The Kentucky Division for Air Quality hereby submits its enclosed comments on the U.S. Environmental Protection Agency's (EPA's) Proposal to Issue Federal Implementation Plans (FIPs) to Reduce Interstate Transport of Fine Particulate Matter and Ozone (75 Federal Register 45210, August 2, 2010). The Division appreciates the opportunity to comment on the U.S. EPA's proposed Transport Rule.

Kentucky Division for Air Quality (Division)
Comments on the U.S. Environmental Protection Agency's (EPA's) Proposal
to Issue Federal Implementation Plans to Reduce Interstate Transport of Fine
Particulate Matter and Ozone (commonly called the Transport Rule)
(75 FR 45210, August 2, 2010)

Subject: Comments by the UIEK on U.S. EPA's Proposed Transport Rule

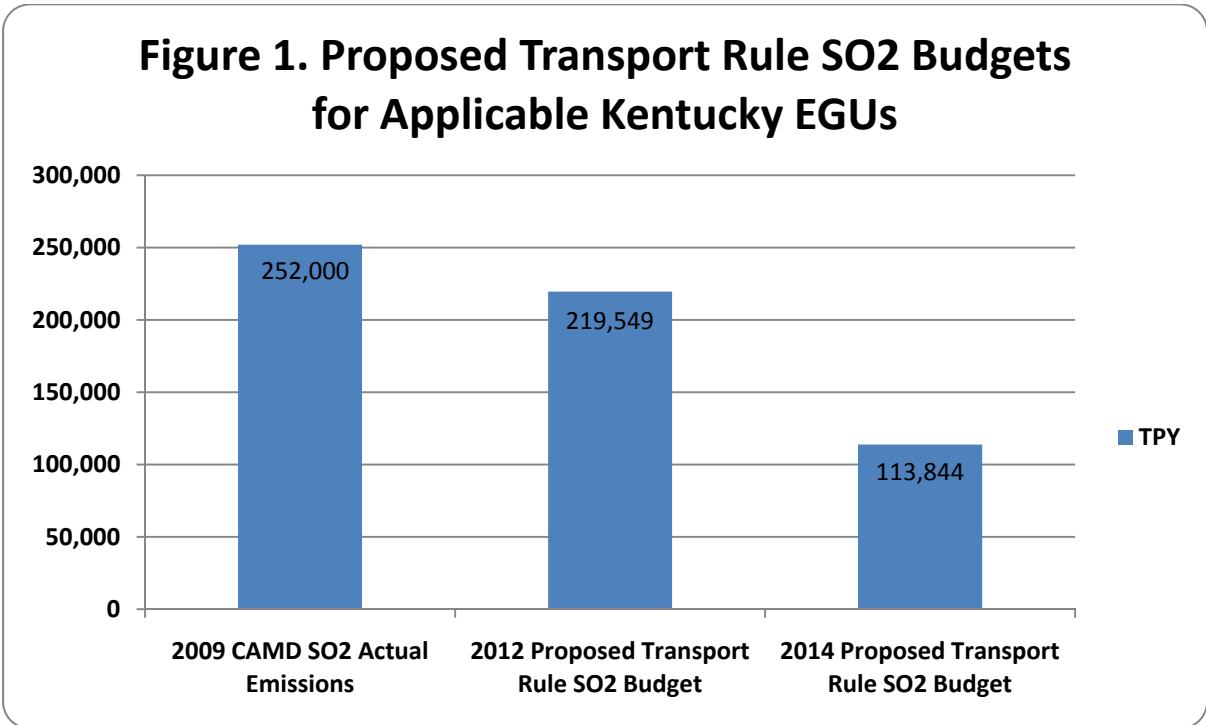
- Pursuant to the proposed Transport rule Preamble Section IV.E., State Emissions Budgets (75 FR 45290-45292), the Division is concerned that the Transport Rule SO₂ emission

budgets being proposed by EPA for Kentucky, especially in 2014, represent a drastic SO₂ emission reduction which may not be achievable by Kentucky sources. Based on the Division's review of 2009 actual SO₂ emissions for Kentucky Electric Generating Units (EGUs) (an estimated 252,000 tpy per 2009 EPA CAMD data), the proposed Transport Rule SO₂ budget in 2012 (219,549 tpy) will be difficult to meet and the proposed rule's SO₂ budget for 2014 (113,844 tpy) will be much more difficult and problematic to achieve given that most large Kentucky EGUs already have flue gas desulfurization (FGD) scrubbers operational before 2012 (*See below Figure 1 and see the attached Table 1 for Kentucky SO₂ FGD controls and 2009 CAMD emissions*). Kentucky has only one remaining large unit (800 MWe) that is not scrubbed. Per a consent decree, this unit will install a FGD scrubber by December 31, 2015. However, this alone cannot achieve the needed SO₂ budget reduction proposed by EPA for 2014.

As indicated by Figure 1, the Transport Rule as proposed would require Kentucky EGUs to reduce their 2009 SO₂ emissions by an estimated 13% by 2012 and reduce their 2009 emissions by an additional 42% by 2014 resulting in a total EGU SO₂ emission reduction of 55% from the Kentucky 2009 EGU SO₂ emission level. In addition, the proposed 2014 Transport Rule SO₂ budget reflects a 48% decrease from the proposed 2012 Transport Rule SO₂ budget for Kentucky EGUs. Even if these drastic emissions reductions being proposed by the Transport Rule are technologically feasible, which is in question, they are unrealistic and not practicable given that achieving such reductions may: (1) lead to disruptions in a reliable power supply in the region; (2) cause certain economic hardships for industry sectors; and (3) drive up the cost of consumer electricity rates. The Division requests that EPA reconsider the SO₂ emission reductions in light of these probable outcomes.

- As indicated by Figure 2, the Transport Rule as proposed would require Kentucky EGUs to reduce their 2009 annual NOx emissions by an estimated 6% by 2012. Notwithstanding the difficulty in obtaining this reduction, the Division is perplexed that EPA has proposed such a drastic budget reduction for SO2 from 2012 to 2014 for

Kentucky (See Figure 1), but has kept the 2012 and 2014 proposed Transport Rule NOx budgets the same (See Figure 2). The Division requests that EPA provide its rationale for this decision.

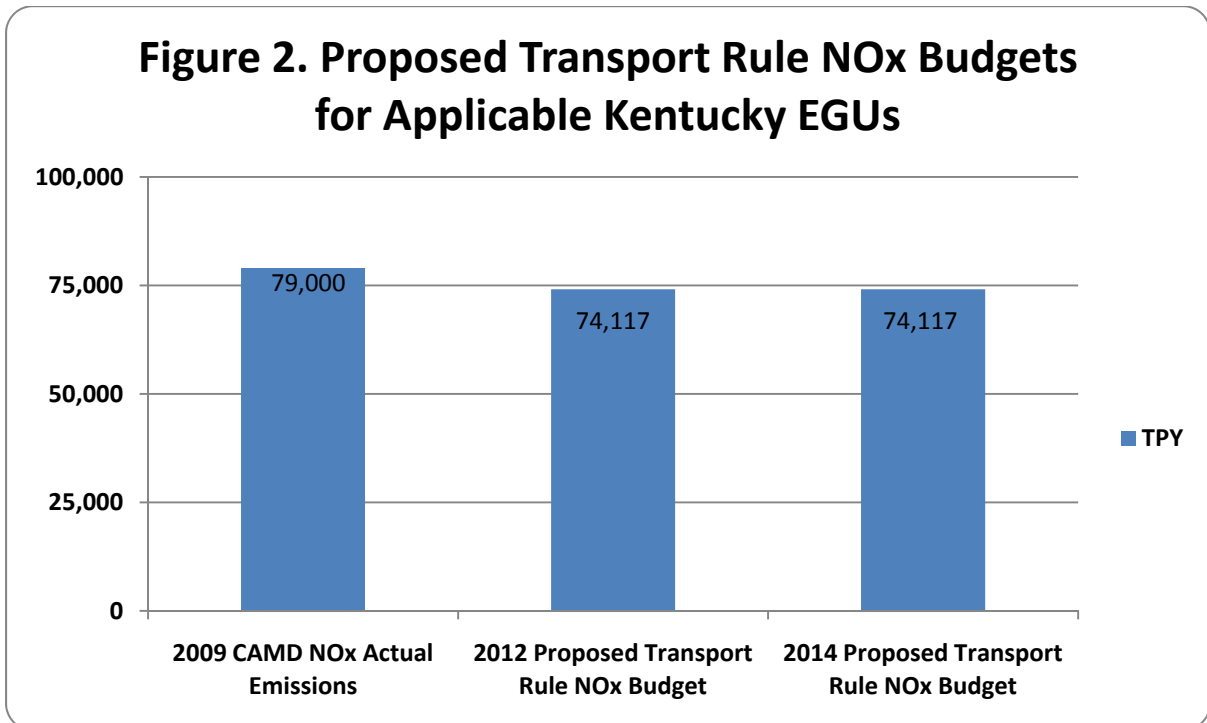
- Pursuant to the rule preamble Section IV.E., State Emissions Budgets (75 FR 45290-45292), based on the Division's review of 2009 actual NOx emissions for Kentucky EGUs (an estimated 79,000 tpy per 2009 EPA CAMD data), the proposed Transport Rule NOx budget in 2012 and 2014 (74,117 tpy) will also be difficult for certain Kentucky EGUs to meet since most Kentucky EGUs already have some type of NOx controls in place (See below Figure 2 and see the attached Table 1 for Kentucky NOx controls and 2009 CAMD emissions).
